Your Ref: 17161650

**OBJECTION - HORSLEY DRIVE BUSINESS PARK – STATE SIGNIFICANT DEVELOPMENT
APPLCIATION 17161650**

Figure 1 – SSD 7664 Conditions of Consent

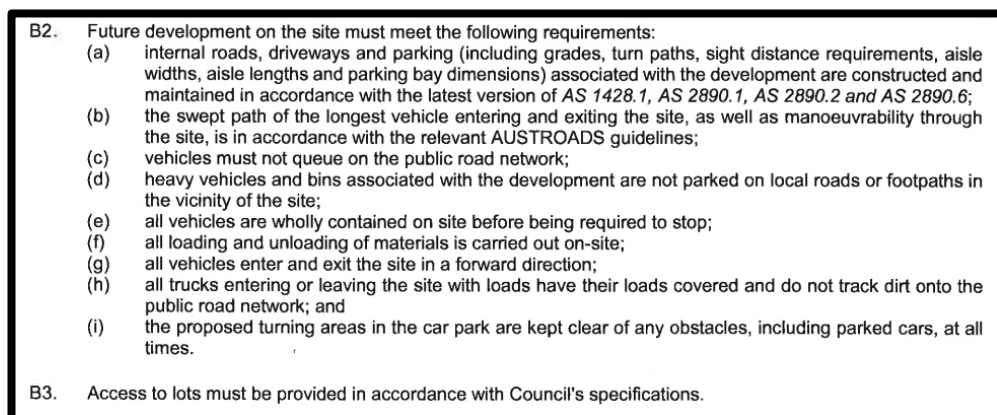
- a. A previous submission by Council (20 April 2021) identified the above identified concerns including potential traffic impacts from the development on the surrounding road network infrastructure, vehicle conflict on the external estate road due to the location of ingress and egress for warehouses 2 and 3 and heavy vehicle circulation in the northwest corner of Warehouse 3. These concerns are not addressed as part of the documentation submitted with the EIS.
- b. SSD 7664 forms the concept plan approval for stage 2 of the HDBP. Conditions B1 and B2 of the approval form requirements relating to traffic and access for the future warehouse 2 and 3 (see Fig 1 below).

It is clear from the EIS that vehicles would be required to stop prior to entering the site and that swept path diagrams submitted with the OTMP show heavy vehicles unable to manoeuvre out of the site without clashing. This forms non-compliance with the conditions of SSD 7664.
